649.5212
Job Sheet 175006

Part Name: Bracket

Note: DWG 649.5200 REV.C SHEETS 1,4 IPP REV:A RQ 13/11/26 New issue VERIFIED BY:DD IPP REV:B 18.03.23 AS PER DWG REV.C DD VERF:JFS

649.5212 SHOWN
649.5214 OPPOSITE

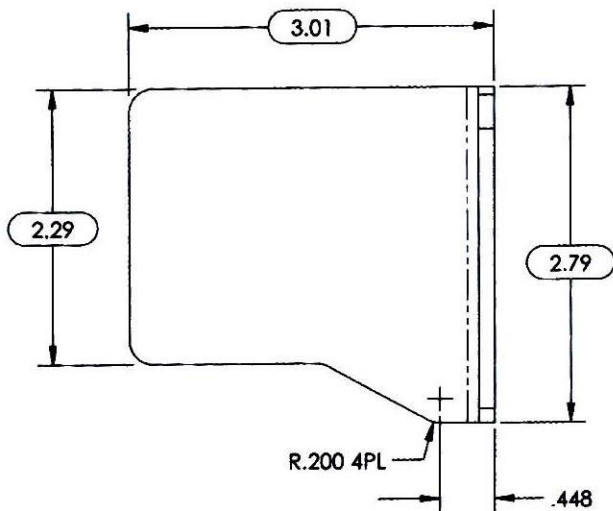
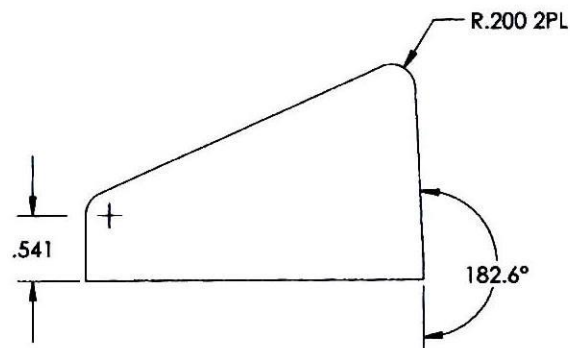
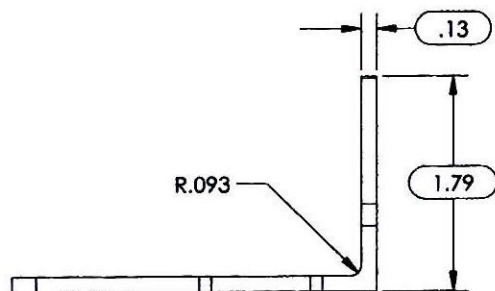
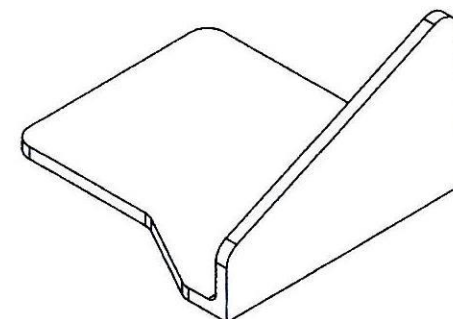
For the record, and I'm not sure why, but Hawkesbury never got a copy of 649.5200 Rev. B. So the last few kits have been shipped with 649.5212/.5214 were still featuring a slight bent. AWPC requested removal of the bent "if possible" to ease installation. I don't believe it is critical to ship AWPC's next kits if 649.5212/.5214 still feature this slight bent. HBY can probably deplete its stock of custom extrusion and then move on to a stock angle iron. However, the 649.5212/.5214 Rev. C must feature the other changes introduced with 649.5200 Rev. C.

For 649.5212/5214 bracket we had made a custom extrusion in the past for it. We still have 129 feet left. Now the new dwg those not have the slit bend in it.

-We would need to order some angle and this could take a few week to receive it.

I agree that we can continue to ship parts using the custom extrusion until we have depleted stock of the material. I'm on board with what you are suggesting below.
